Methodology

Previously Surveyed Historic Resources

405 Concord Transitional Craftsman, 1902

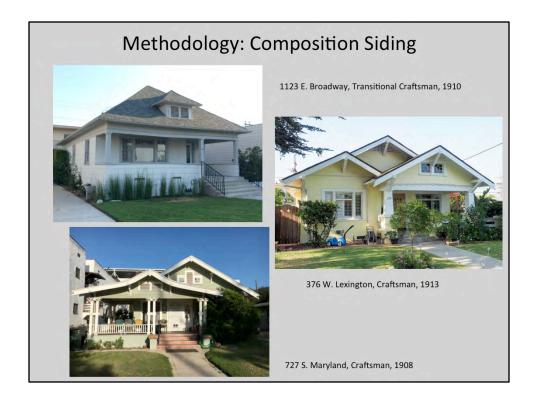
HRG: both added as 6L. TGHS believes the HPC would find these properties eligible for the Glendale Register (5S3) despite early porch enclosures and asks that the Commission reject this portion of the Methodology. The HPC recently approved the Craftsman-style Beggs House for the Glendale Register despite an early enclosed porch. Consistent with HRG's Methodology Statement, "For the earliest [buildings], (late 19th century into the first years of the 20th century) a greater degree of alteration was determined acceptable due to the rarity of these resources" (p. 5, emphasis added), which applies to 405 Concord. There is no evidence to suggest the roofline has been altered at this property as claimed by HRG. It is a very early, clearly recognizable Transitional Craftsman. For 137 S Jackson, the Registration Requirements for historic resources listed in HRG's Historic Context Statement (September 2014) specifically advise that "Resources from this period [1918 and before] are increasingly rare" (p. 57), and "Due to tremendous development pressures throughout South Glendale's history, properties and features from this period are rare; therefore a greater degree of alteration may be acceptable" (p. 59, emphasis added).

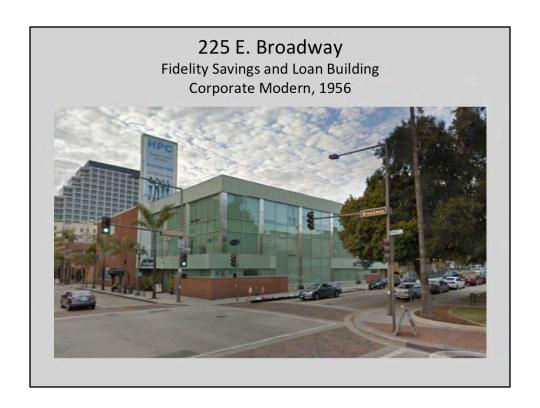
HRG: 3CS (eligible for the California Register). In comments HRG states that it "does not appear eligible for National or California Registers." Is it California Register eligible or not? This building was designed by internationally renowned architect W. A. Sarmiento and was found eligible for the National and California Registers in cityadopted Jones & Stokes Survey of 2006. Contrary to HRG's rationale for downgrading the property, the spandrel panels remain intact; louvers were removed, but these were later additions. Some new windows in existing openings may comply with the Standards for Rehabilitation, particularly when the change is necessary to accommodate a new use.

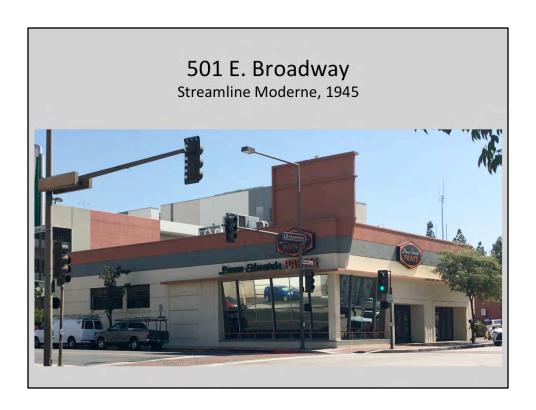
HRG: downgraded to 6Z. Found eligible for the Glendale Register (5S3) in the city-adopted Jones & Stokes Downtown Survey in 2006. At that time it was rightly called "one of the best remaining commercial properties *in Glendale* from the 1940s" (emphasis added). It has not been altered since, and it retains obvious character-defining features of the Streamline Moderne style, including its highly distinctive "chimney" with fillets, cantilevered canopy, and large canted windows. There is no justification for changing its status. HRG identifies only two 1940s commercial retail buildings as locally eligible: the Great White Hut (121 E. California, vernacular, 1941, downgraded from National Register-eligible) and the Salvation Army Building (801 S. Central, Spanish, 1940). No Streamline Moderne building was found to be a historic resource in the Survey (220 N. Glendale, a late Moderne office building was added at TGHS's behest). Streamline Moderne is a rare resource type; we believe that the HPC would find it eligible for the Glendale Register.

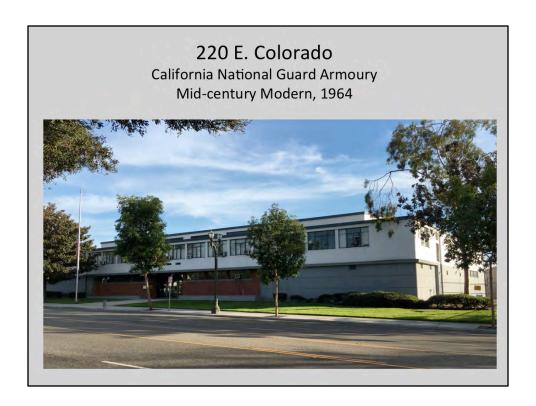
HRG: downgraded to 5S3, locally eligible. Found eligible for the National and California Registers in the Jones & Stokes Downtown Survey in 2006. Its rarity as a type, locally, regionally, and nationally, has only increased in the past decade.

HRG: downgraded to 6Z. Found eligible for the California Register in the city-adopted Jones & Stokes Downtown Survey of 2006 "because it embodies distinctive characteristics of a type and period of construction" and for its association with the National Guard pending an intensive evaluation. Character-defining features include planar walls, steel sash ribbon windows, stack bond and sand-finished scored stucco in a rectangular grid pattern, and a cantilevered second story. No alterations since previous finding of eligibility are noted. We believe that the HPC would find this property eligible for the Glendale Register for its architecture.

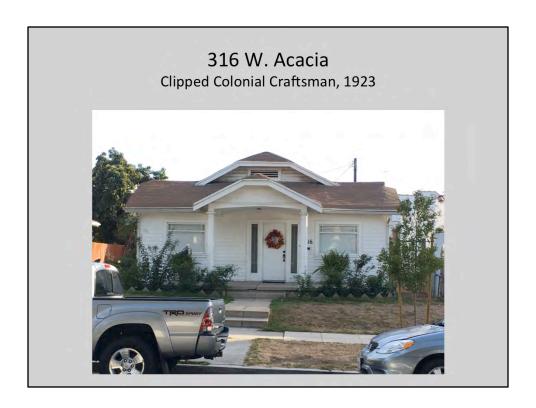
HRG: added to Survey as 6L. This was previously found eligible for the Glendale Register (5S3) in the city-adopted Craftsman Survey of 2007. It appears to be unaltered since that time. Consistent with HRG's Methodology, which identifies as locally eligible intact Craftsmans from 1919-1925 "with some degree of architectural detail" (p. 21), this high-integrity Craftsman with its distinctive asymmetrical front facade and matching clipped-roof garage should qualify as a historic resource. We believe the HPC would find it eligible for the Glendale Register.

HRG: downgraded to 6Z, substantially altered. 407 Naranja is already a locally eligible historic resource (5S3) based on findings in the city-adopted Craftsman Survey of 2007. Disqualifying alterations must be described. Early alterations are not intrinsically disqualifying.

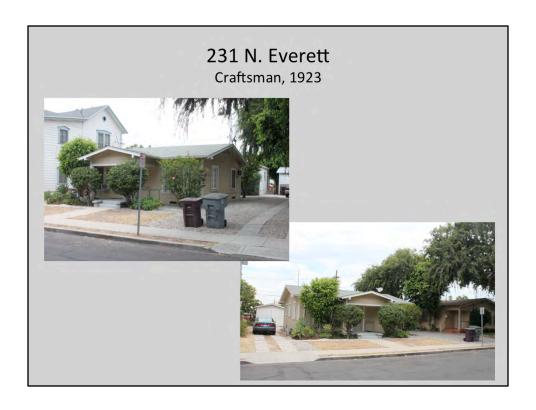
HRG: 6L. TGHS believes these buildings are individually eligible and qualify as a historic district, along with 823 Milford, which HRG found to be individually eligible (5S3). The 1996 San Fernando Road Corridor Survey states that "the 800 block of Milford and the 500 block of Commercial contain the best examples of a group of industrial buildings within the San Fernando Road project area dating from the second quarter of the twentieth century...It is recommended that these buildings be considered eligible for the National Register as a group of related buildings" (emphasis added). HRG has not acknowledged the findings of this Survey in its own evaluation. TGHS continues to believe these three related industrial buildings along with 823 Milford, all of which were built by prominent Glendalebased architect and City Council member Merrill Baird for Fred Peterson, are eligible for the Glendale Register. Three of Baird's projects are listed in the Glendale Register, including the Glendale Municipal Building, which he designed with A. C. Martin. Peterson co-owned Modern Refrigerator Works with his brother Arthur; it operated out of 823 Milford and 514 Commercial (top photo) for almost seventy years. 823 Milford and 514 Commercial are connected but occupy separate assessor parcels. Whether or not the HPC agrees that these are individually eligible we request that Commissioners ask HRG and staff to find the four buildings eligible as a local historic district.

HRG: 6Z "slated for demolition" (this appears to be incorrect). L. H. Wilson was the leading figure in the development of the San Fernando Road Corridor. He built dozens of buildings and actively brought businesses to the area; according to HRG, in 1928 alone he "brokered deals that brought 14 companies to the San Fernando Road area and built nine industrial buildings, five of which he sold before the end of that year" (HRG, "3901 San Fernando Road Historic Resources Assessment, October 9, 2013, 2). In 2013 HRG found 3901 San Fernando Road, also built by Wilson, eligible for the Glendale Register for its association with L. H. Wilson, as "a person who significantly contributed to the history of the City." That building has since been demolished. 4500 San Fernando Road is his earliest known extant building and his only known remaining commercial building; the others are all industrial properties. No Wilson buildings have been identified as historic resources in the Survey. The Registration Requirements for commercial buildings from 1919-1929, prepared by HRG in the South Glendale Historic Context Statement, state: "Due to tremendous development pressures throughout South Glendale's history, properties from this period are relatively rare; therefore a greater degree of alteration may be acceptable" (121). We believe that the HPC would find this eligible for the Glendale Register for its association with L. H. Wilson and for its architecture.

HRG: 7R (not evaluated), previously 6L. We believe that the HPC would find 231 N. Everett eligible for the Glendale Register for its association with one of Glendale's pioneering families. It retains high-integrity. 231 N. Everett was built by Ruth Byram, daughter of early Glendale settlers Ellis T. Byram and Huldah Byram. HRG's claim that 231 and 233 N Everett (built by Ruth's brother Ralph, next page), were not part of the Byram farmhouse property is incorrect. In 1887 E. T. Byram transferred title to the property, which encompassed 14 lots, to his wife Huldah (property deed, Sept. 8, 1887, Block 3, Glendale, LA County Recorder, 282:273). This property included the Byram House (formerly 228 N Glendale, now 227 N. Everett, visible in upper photo) and extended north to present-day California St., including the lots on which 231 and 233 N. Everett were built. Ellis Byram died in 1908; his wife Huldah continued to live at the farmhouse with daughters Ruth and Eva and son-in-law Joseph Banker at least until 1923, when the houses were built next door [1920 Census; 1923 Directory]. Together with neighboring Byram House (upper left) and 233 N. Everett, 231 N. Everett illustrates the evolving presence and legacy of this pioneer family over half a century in Glendale.

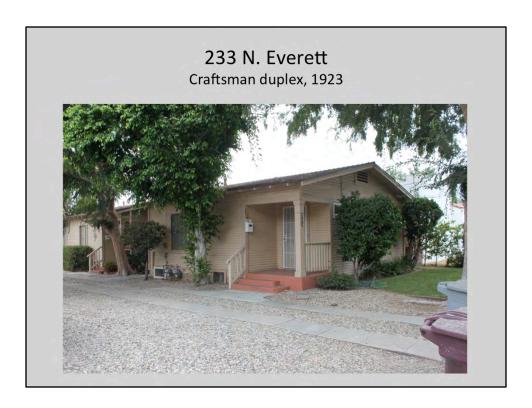
HRG: 7R (not evaluated), previously 6L. 233 N. Everett was built by Ralph Byram, son of Glendale settlers Ellis T. Byram and Huldah Byram, on the original farmhouse property. Together with neighboring Byram House and 231 N. Everett (previous page), this property illustrates the evolving presence and legacy of this pioneer family over half a century in Glendale. It retains high integrity. We believe the HPC would find it eligible for the Glendale Register for this association and as a rare Craftsman duplex.

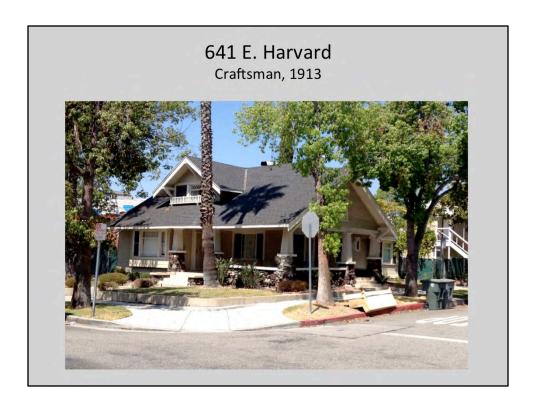
HRG: added as 6L. We believe the HPC would find this property eligible for the Glendale Register for its association with Herman Nelson, a prominent business leader in early Glendale. At the time this house was built, Nelson was a Director as well as Secretary, Treasurer, and Cashier of the Bank of Glendale, the city's first bank, organized in 1905. When the Bank of Glendale was acquired in 1920 by Los Angeles Trust and Savings Bank, Nelson remained as the local manager and later became a vice president of that bank. He was active in civic life and is covered in John Calvin Sherer's History of Glendale and Vicinity (1922). To be found significant for its association with an important local person the property needs to retain sufficient integrity to be recognizable to that person, which it does. And that person needs to have lived there when making his or her local contributions, which he did. Nelson may have been the original builder/resident; in the absence of a building permit, available city directories show that he lived there from at least 1915 (under its old address, 503 W. 5th St.) and still resided there in 1936. He moved to Rossmoyne by 1940.

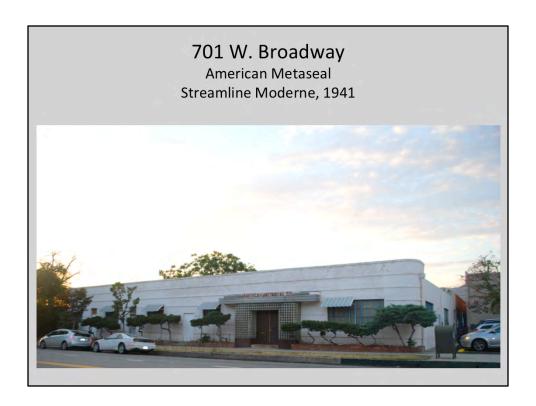
HRG: added as 6L. TGHS strongly disagrees that this rare Streamline Moderne industrial building is not distinctive. It is one of the very few examples of this style in Glendale and retains high integrity. No Streamline Moderne buildings of any kind were identified as historic resources in the Survey (HRG added one Late Moderne office building at 220 N. Glendale at TGHS's behest). It is a one-story, painted brick building with banded brick fillets, a brick parapet, banded metal canopy with 1950s signage, a glass block entry, and brick planting boxes. We believe that the HPC would find this building eligible for the Glendale Register as a rare example of the Streamline Moderne style.

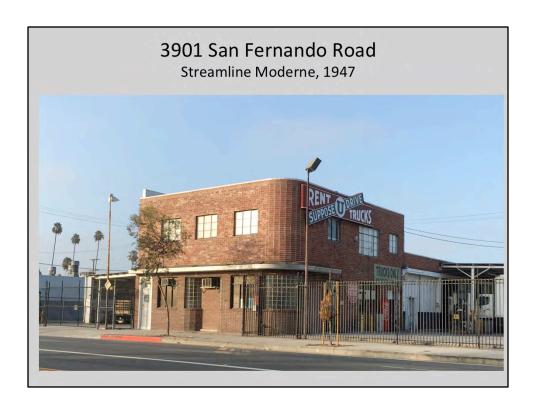
HRG: added as 6L. This Quonset hut is a rare, possibly unique resource type in Glendale. According to SurveyLA's Historic Context Statement on the Quonset Hut, 1941-1965: "an important symbol of mid-century utilitarian design and construction, the Quonset hut is a rapidly disappearing building type." We believe the HPC would find it eligible for the Glendale Register.

HRG: added as 6L. TGHS strongly disagrees that this rare two-story Streamline Moderne commercial building is not distinctive. HRG called it out as an example of this rare style in the South Glendale Historic Context Statement. There is no evidence that the second story was added later. On the contrary, the brick is differentiated between first and second stories at the cantilevered canopy at the front, which is not surprising; indeed, the different types of brickwork, including a third treatment at the rounded "corner," is part of its distinctive design. No Streamline Moderne buildings of any kind have been identified as historic resources in the Survey (HRG did add one Late Moderne office building at 220 N. Glendale at TGHS's behest). We believe the HPC would find this eligible for the Glendale Register.

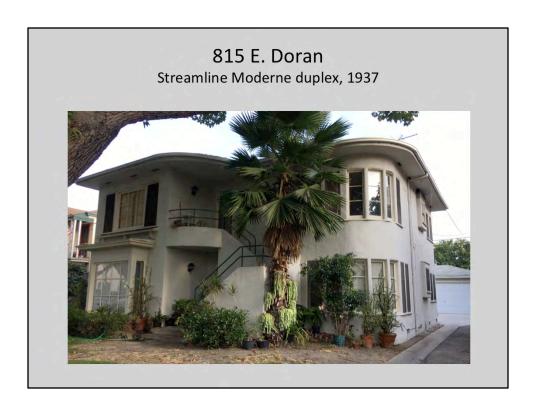
HRG: added as 6L. TGHS originally requested a 6L status code but believes this property should be added as 5S3 given extreme rarity of the type. No other English or Tudor Revival duplexes are identified in the Survey. No known alterations.

Good and rare example of Streamline Moderne duplex. Identified by HRG as a contributor to the proposed E. Doran Street historic district but appears to be individually eligible (status code 5B). There are no Streamline Moderne residential properties identified as historic resources in the Survey; no Streamline Moderne buildings were identified at all. Character-defining features include curved roof and building plan, radius curved front corner with two stories of windows, radius curved balcony and handrails, distinctive front entry doors with intersecting line motif. We believe the HPC would find it eligible for the Glendale Register.

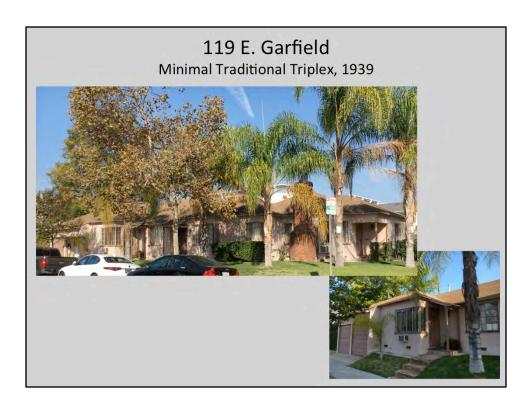
HRG: added as 6L. There are no Minimal Traditional duplexes and only one or two triplexes of any style in the Survey. HRG asserts the existence of "many examples of these properties in other areas of Glendale"; however, it must provide addresses of actual and better examples of high-integrity Minimal Traditional triplexes (or even duplexes) elsewhere. We don't know of a finer example in the City; others have alterations, large apartment buildings attached in the rear, or lack the detail and design quality of this one. We believe the HPC would find this eligible for the Glendale Register.

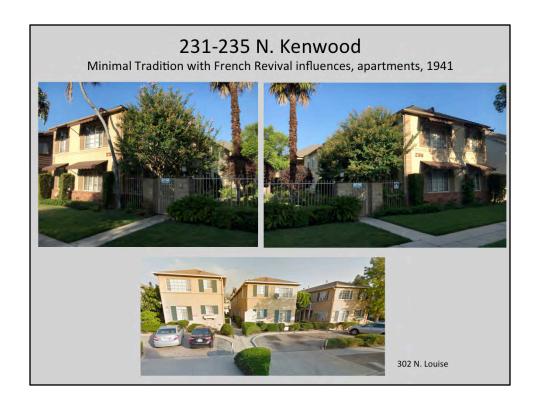
HRG: 6Z. There are numerous dingbats in Glendale, but none were found to be historic resources. We believe this partial dingbat with its "worm-eaten"-style wood siding and stack-bond Roman brick is the best example in Glendale. HRG should identify superior examples of the style in Glendale if this one does not qualify as a "good example."

HRG: 6L. We strongly disagree with HRG's conclusion that 231-235 N. Kenwood is unremarkable in its own right or inferior in comparison with other examples identified from this period in the Survey, such as 302 N. Louise, which is a fine example but lacks the rarer French Revival influence described by HRG. It was found eligible for the Glendale Register. 231 – 235 N. Kenwood compares favorably with 1434 and 1458 E. Wilson, which were also found eligible. We believe the HPC would find this property eligible for the Glendale Register. The reversible addition of the security fence and awnings are not remotely disqualifying.

HRG: 6Z. TGHS strongly disagrees that this is not a distinctive example of a postwar garden apartment. Its simple streamlined features include original steel-sash windows that turn at the rounded "corners"--this in itself is a distinctive feature. It has the original brick walkway leading to a lush garden at right and a brick water table. We believe the HPC would find it eligible for the Glendale Register.

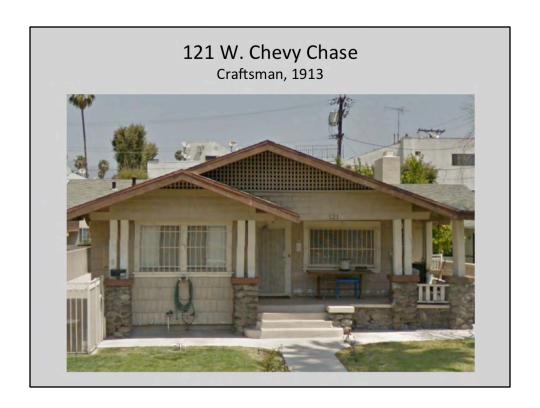
HRG: added as 6L due to alterations. But HRG notes only one replacement window at the front façade and trivial, reversible additions of security bars and door. Consistent with HRG's Methodology that "the primary facade must be largely intact" (p. 20) for Craftsmans built before 1918, this 1913 property should qualify as a historic resource. We believe the HPC would find it eligible for the Glendale Register.

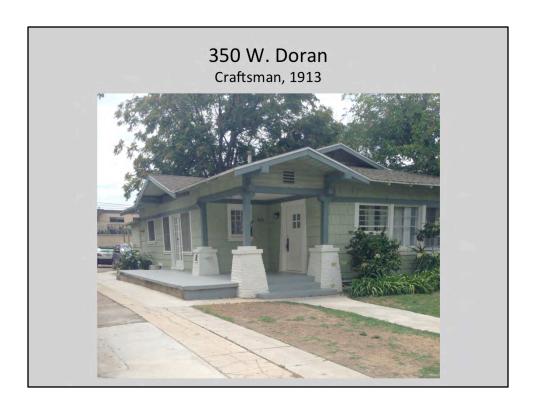
HRG: added as 6L. Consistent with HRG's Methodology that "the primary facade must be largely intact" (p. 20) for Craftsmans built before 1918, we note that some but not all windows at front façade have been replaced and that all original openings remain. We believe the HPC would find it eligible for the Glendale Register.

HRG: added as 6L, not distinctive and porch enclosed per Sanborn maps. Both units have small recessed entry porches, which are intact; HRG appears to be referring to the long ago enclosure of a small porch to the rear of the property on the north side, which is barely visible from the street. This is a rare, early Craftsman-style multifamily development that should be added as 5S3 consistent with other Craftsman multi-families identified by HRG in the Survey. We believe the HPC would find it eligible for the Glendale Register

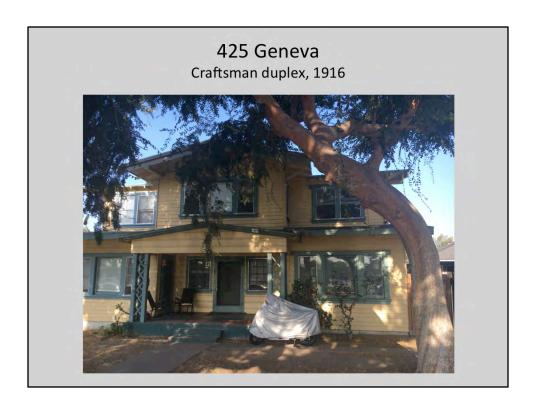
HRG: 6L in original Survey. Consistent with HRG's Methodology, which identifies as locally eligible intact Craftsmans from 1919-1925 "with some degree of architectural detail" (p. 21), this distinctive and high-integrity Craftsman with nested gables, a decorative truss in the front gable, and natural stone piers with tapered porch supports qualifies as a historic resource. The door does not appear to have been altered as Survey originally claimed, and windows and siding are original. It is one of only three high-integrity Craftsmans that remain in the Diamond District, which was once replete with them. We believe the HPC would find it eligible for the Glendale Register. Please note landscaping renders photography difficult.

HRG: planning district. This is an excellent example of the Craftsman style from 1913 with very unusual decorative features, in particular the prominent battered oatmeal stucco piers with battered porch railing and pointed niches and shingles with keynote variations. It has not been assigned a status code, just a comment that it is part of a "planning district" for the Diamond. Given that "planning district" does not have any legal meaning in Glendale, TGHS does not believe this is a satisfactory alternative to a status code. Indeed, the Diamond is full of early Craftsmans with similar alterations that deserve a status code of at least 6L. We believe that the HPC would find this 1913 property eligible for the Glendale Register despite altered windows.

HRG: planning district. This is a remarkable Craftsman from 1911 with a central gable flanked by unusual symmetrical side gables that lower to meet the main roof plane, lattice work in all three gables, a wood sill course, and exaggerated battered sides. There is not another one like it in Glendale. We believe the HPC would find it eligible for the Glendale Register despite altered windows. Given that "Planning District" does not have any legal meaning in Glendale, TGHS does not believe this is a satisfactory alternative to a status code.

HRG: added as 6L. Consistent with HRG's Methodology that "the primary facade must be largely intact" (p. 20) for Craftsmans built before 1918, we note that some but not all windows in the primary facade have been replaced, in the original openings. The relocation of the duplex in 1938 is not disqualifying. Both two-story and Craftsman duplexes are rare. We believe the HPC would find it eligible for the Glendale Register.

HRG: 6Z due to alterations. HRG's research has confirmed that this Craftsman was built in 1903. Only five properties identified in the Survey as historic resources predate this; one at 819 E. Wilson (1901) was labeled 5S3 despite replacement of windows due to early construction date. Consistent with HRG's Methodology Statement, "For the earliest examples, (late 19th century into the first years of the 20th century) a greater degree of alteration was determined acceptable due to the rarity of these resources" (p. 5). We suggest these alterations to a 1903 Craftsman are non-disqualifying due to early construction date; the porch enclosure was early, and the alteration to the bay window at the side is not visible from the public right of way, as this photo indicates. We believe the HPC would find it eligible for the Glendale Register.

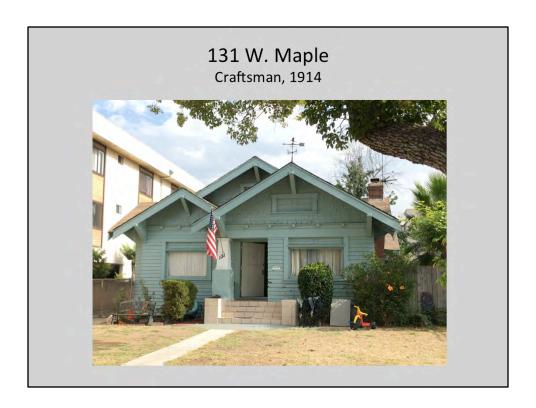
HRG: 6L, "not distinctive." Consistent with HRG's Methodology, which identifies as locally eligible intact Craftsmans from 1919-1925 "with some degree of architectural detail" (p. 21), this high-integrity Clipped Colonial Craftsman should qualify as a historic resource. Its character-defining features include fixed front façade windows with multi-light uppers on either side of door and in front gable transom, partial sidelights and original single-panel door, fascia with decorative return and shaped header. TGHS believes the HPC would find it eligible for the Glendale Register.

HRG: 6L. Consistent with HRG's Methodology that "the primary facade must be largely intact" (p. 20) for Craftsmans built before 1918, we note that alteration to steps and porch post should not disqualify this distinctive 1914 Craftsman. Features include nested gables, thumbrails at windows, original and distinctive picture windows, Hollywood-style driveway. We believe the HPC would find this eligible for the Glendale Register.

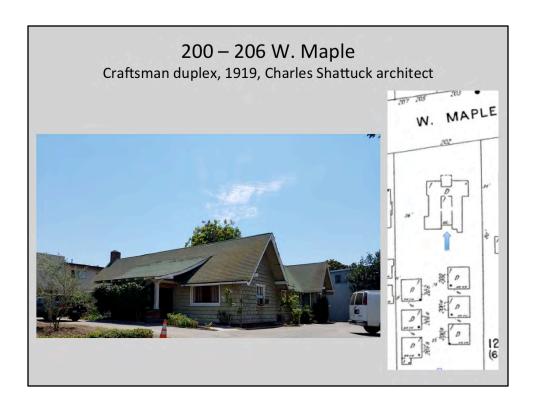
HRG: added as 6L. Charles Shattuck is recognized by the City of Glendale as an important local architect. This alone should qualify this building for the Glendale Register apart from the rarity of Craftsman duplexes in Glendale. The Sanborn map reveals that the building was not a U-shape, as HRG claims, but a rectangle with some central configuration and a solid wall at the rear (denoted by the solid line). We believe the HPC would find it eligible for the Glendale Register. A high-integrity Craftsman bungalow court (also on the 1925 Sanborn map) still exists at the rear of the property, but that is not visible from the public right of way.

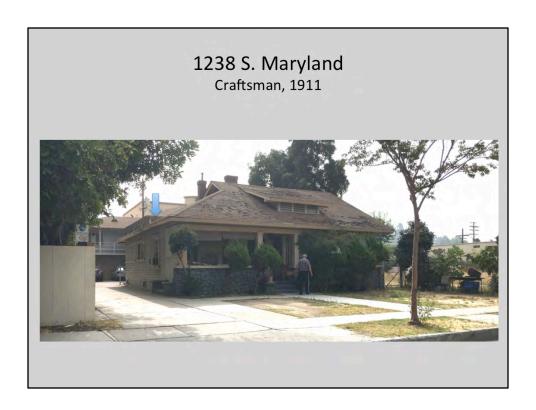
HRG: "6L due to alterations," but no disqualifying alterations are described. There is a reversible screen door and a rear apartment building (in the photograph, it looks almost like a second-story addition at the left rear, where the arrow is, but it's a separate building). We note that historic resources in Glendale have been and are proposed to be surrounded by large and, indeed, overwhelming new construction (512 W. Doran; the Goode House), so the presence of proximate buildings is not disqualifying. We believe the HPC would find this 1911 Craftsman eligible for the Glendale Register.

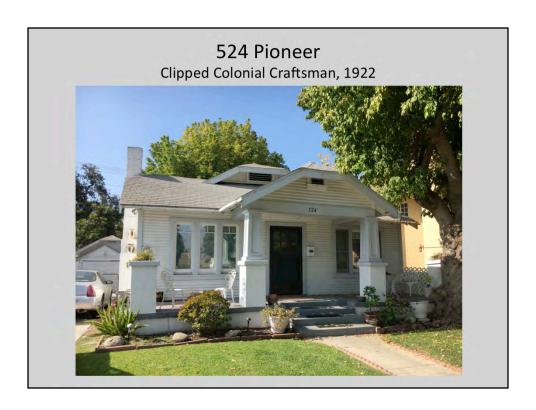
HRG: added as 6L "not distinctive." Consistent with HRG's Methodology, which identifies as locally eligible intact Craftsmans from 1919-1925 "with some degree of architectural detail" (p. 21), this high-integrity Clipped Colonial Craftsman with clipped dormer, decorative recessed porch supports, overpainted brick chimney, and matching clipped gable at the garage should qualify as a historic resource. TGHS believes the HPC would find it eligible for the Glendale Register.

HRG: 6L. There is no evidence that the roofline or massing have been altered, as HRG claims. There is a small shed-roof extension in the rear (comparison of aerial image with 1919 Sanborn map). The City has been notified about the unpermitted alterations; we believe the HPC would find this eligible for the Glendale Register if the owner is required to restore to previous condition. It already has been identified as warranting special consideration in planning, which would necessitate removal of its incompatible siding regardless. Original wood siding was not covered over or replaced at sides; the brickwork is almost certainly intact.
